TOWN OF FORT MILL PLANNING COMMISSION MEETING

January 19, 2016
112 Confederate Street
7:00 PM

AGENDA

SHEET NUMBER
L100

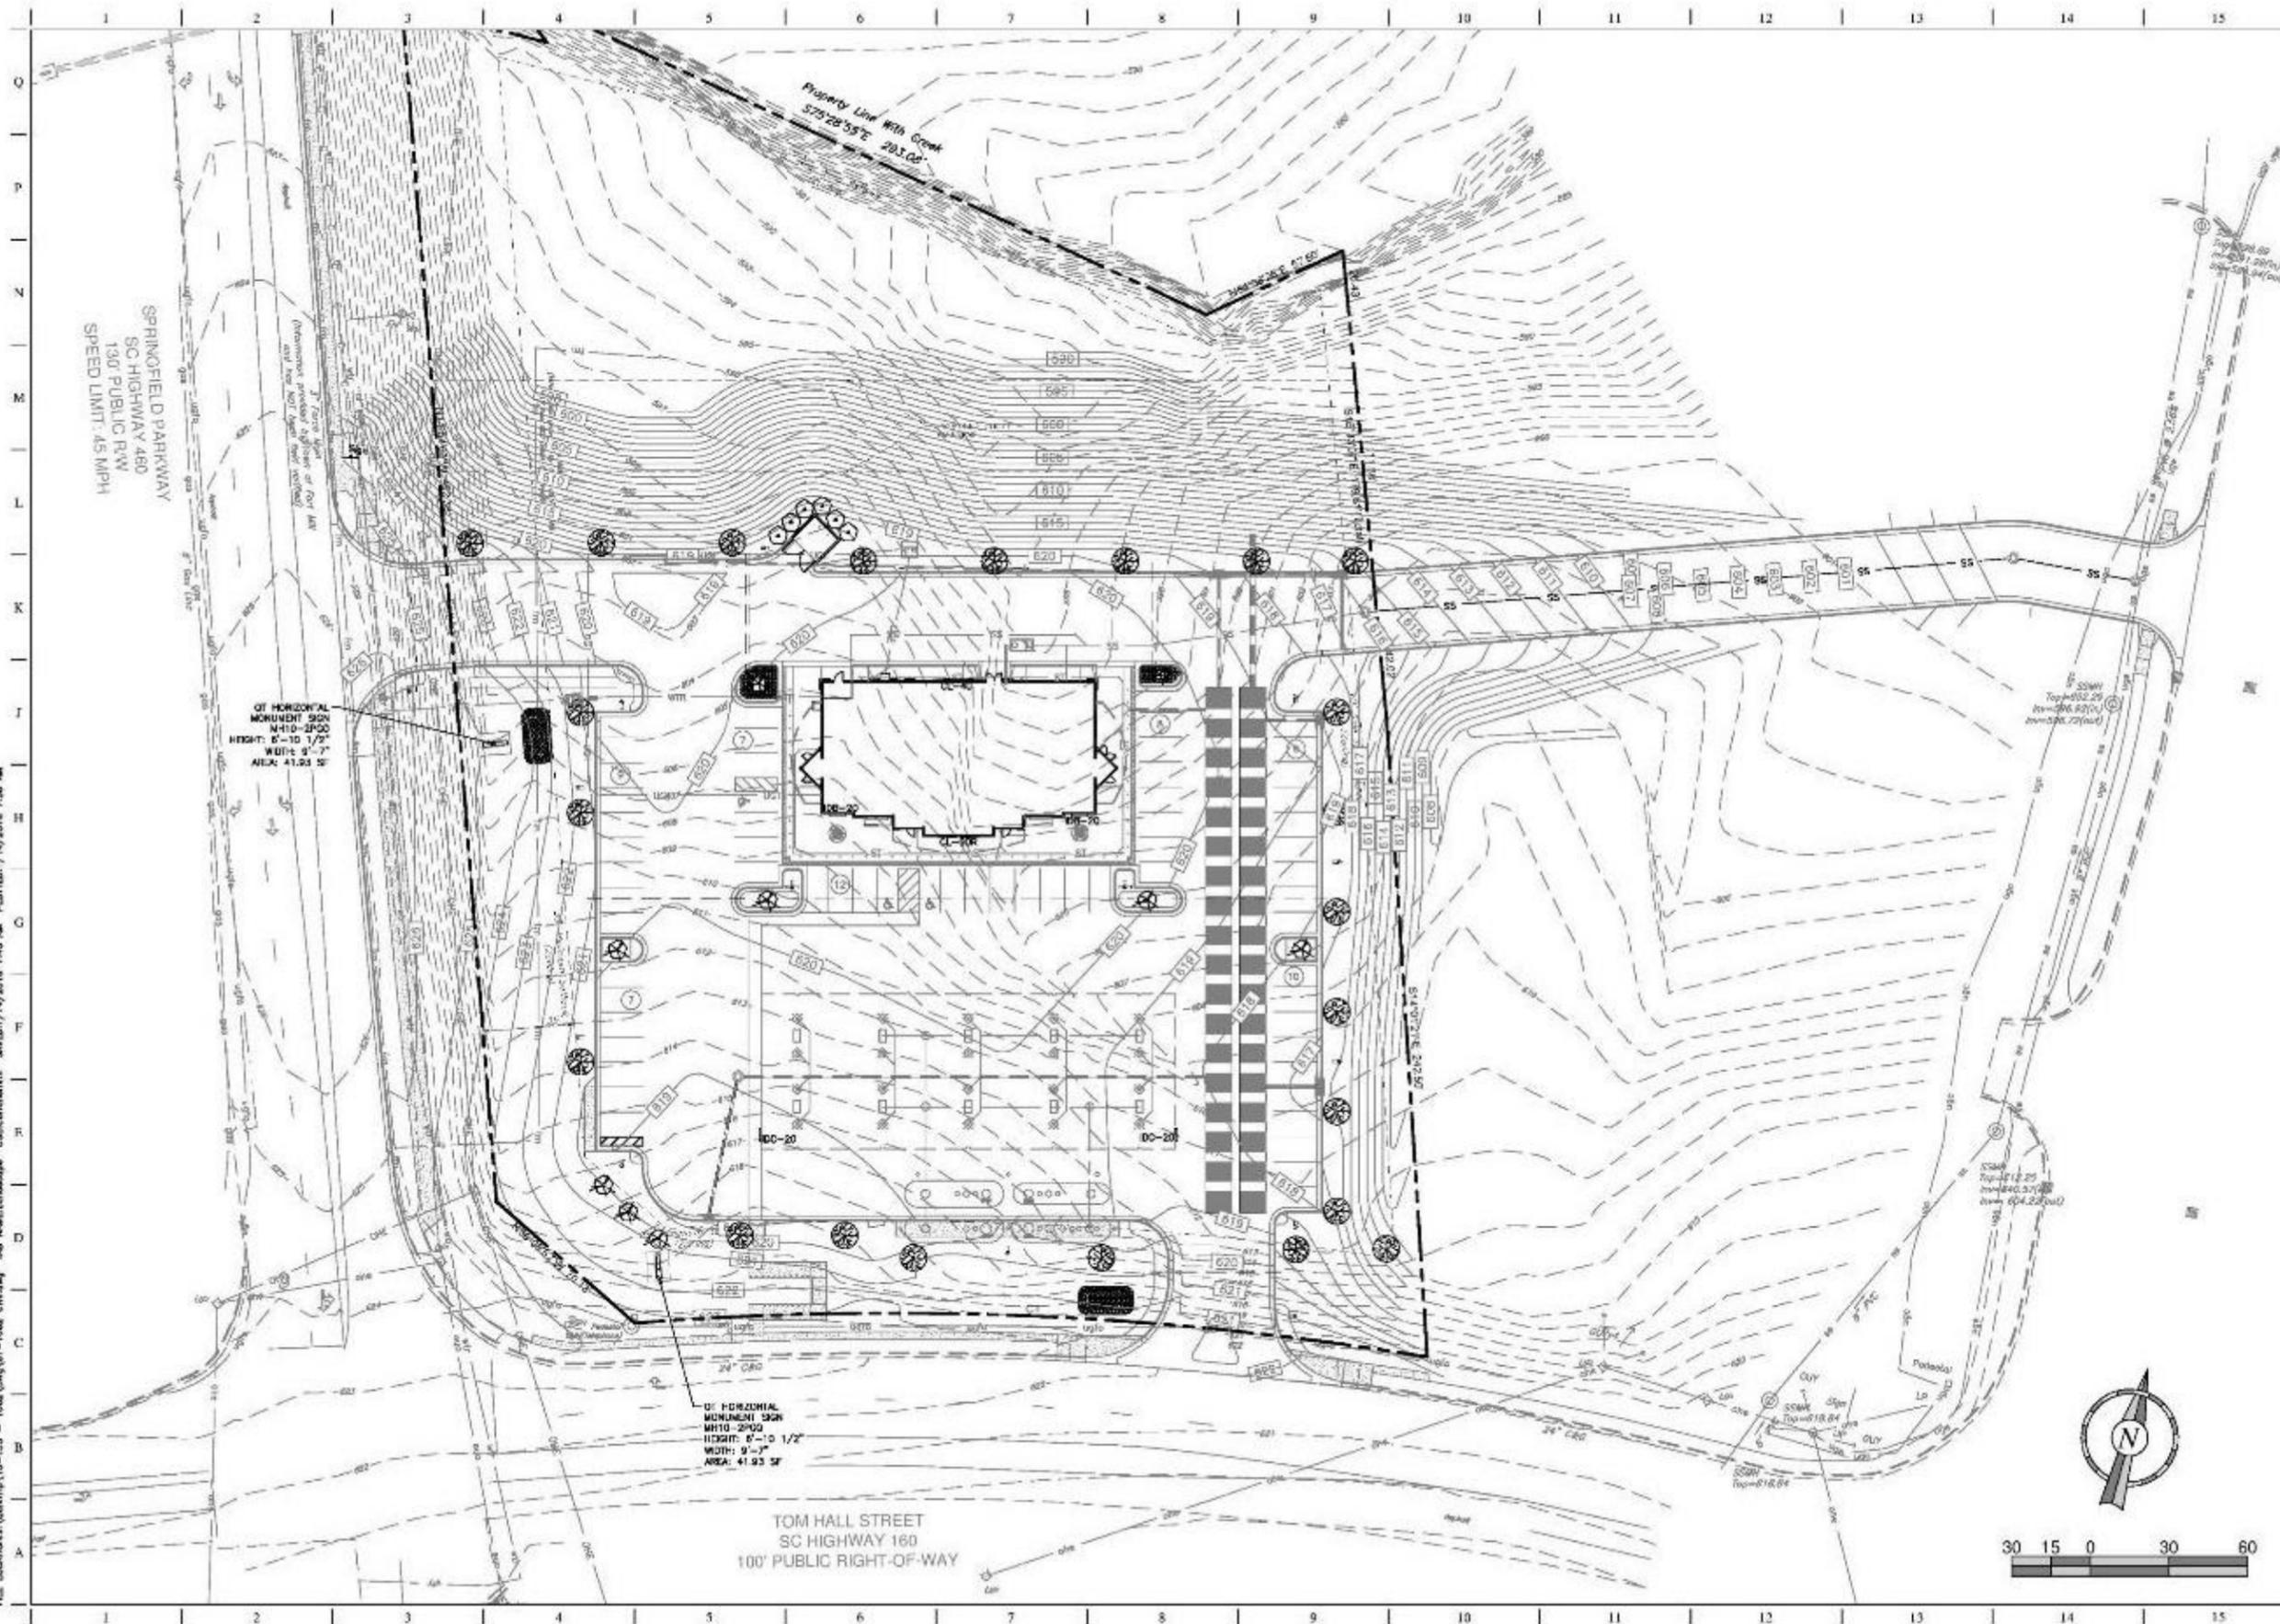
The applicant has supplied a landscape plan showing a mixture of crape myrtle and skyline honeylocust trees within the parking lot and along the project perimeter. Shrubbery was also included in two locations. Staff will note the following requirements of the COD-N:

1. Street trees are to be provided at a rate of one tree per 50 linear feet of frontage. In this case, the frontage would include Highway 160 as well as Springfield Parkway. The applicant has provided the appropriate number of plantings, however these plantings are to all be located within 15’ of the frontage ROWs. As shown, these trees surround the entire property perimeter.

2. Additional plantings are determined by calculating the “planting area” defined in “Streetscape” section of the COD-N overlay requirements. Per staff’s calculation (756.05 LF – (2)45’ entrances), the following would need to be planted within 35’ of the frontage ROW:

- b. 94 shrubs, with 50% being evergreen (the applicant has shown a total of 106 shrubs located in two planting areas). See bullet #4.
3. A tree survey marking significant trees to be removed/protected was not provided, therefore compliance cannot be determined. Any trees 30 inches or more in diameter that are saved shall count towards the required planting requirements. Any trees 30 inches or

4. Off-street parking areas are to be screened from frontage ROWs by a minimum of one row of evergreen shrubs planted no more than 5’ on center. Staff calculates a total of 133 shrubs would be required to meet this requirement. These shrubs may be used to meet the requirements listed in bullet #2(b).
5. The proposed dumpster enclosure would require three sides of landscaped screening.
6. The parking lot would be required to have a total of 7 trees. Such trees cannot be utilized to meet both parking lot landscaping requirements and other requirements listed previously.
7. The trees provided are to be from the approved tree species list provided in Section 38-71 of the Code of Ordinances. Staff will defer compliance with this requirement to the resident landscape architect on the commission.

The landscaping as presented by staff is the minimum required by code. Because of the building orientation and placement, as mentioned in a previous comment, the applicant should go beyond what is minimally required to create an enhanced pedestrian realm.

- In addition to the 16 required street trees, 3 additional trees (50% canopy trees) would be required in the first 35’ adjacent to HWY 160 and Springfield Parkway ROWs. The applicant currently shows approximately 15 trees in the general location along the ROWs (not necessarily within the first 35’). **The landscape plan would ultimately need to be revised to show 16 trees in the first 15’ from the street and an additional 3 trees located within the first 35’ from the street.**

- A tree survey was not provided showing significant trees to be removed. Any trees 30” or more that are saved shall count toward the required plantings requirements. Any trees 30” or more that are removed must be replaced with a 6” caliper tree of similar species.

- A total of 133 evergreen shrubs would be required to screen the parking lot from the adjacent street ROWs. The landscape plan includes shrubbery, however it is not utilized to screen the parking lot. Those shrubs would need to be placed along the frontages to screen the parking lot.

Store #	1062	Double Stack 8 Canopy Elevations	Address:	160 HWY & Springfield Parkway	City, State:	Fort Mill, SC	
Serial #	81-1062-GD08	Scale:	NTS	Issue Date:	12/04/15	Drawn By:	CDC
			Rev/Notes:

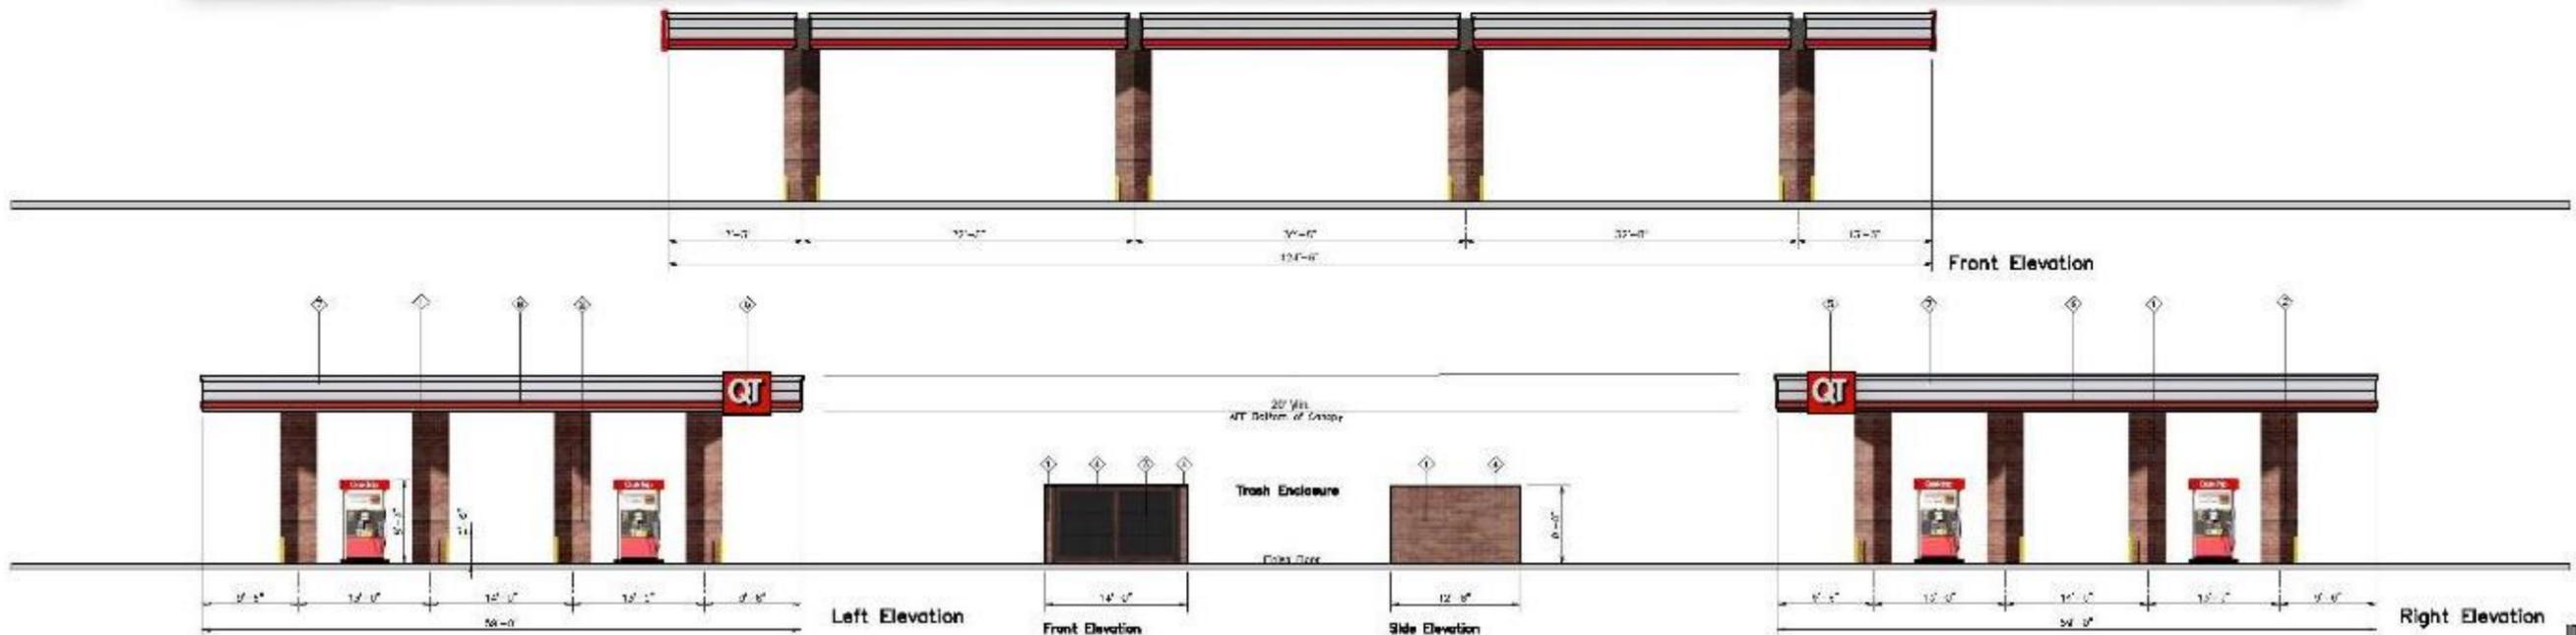
The gas canopy drawings were revised to show the bottom of the canopy at a 20' minimum height. The primary structure's drawings were not revised, still showing the brick portion of the building topping out at 16'.

The rear façade of the building was not revised to incorporate the Planning Commission's preliminary comments. The submission appears to be unchanged from the preliminary submittal.

The building materials as presented are appropriate for the COD-N overlay. For bullet #3 listed above, see the Planning Commission comments made regarding “Building Placement and Orientation”
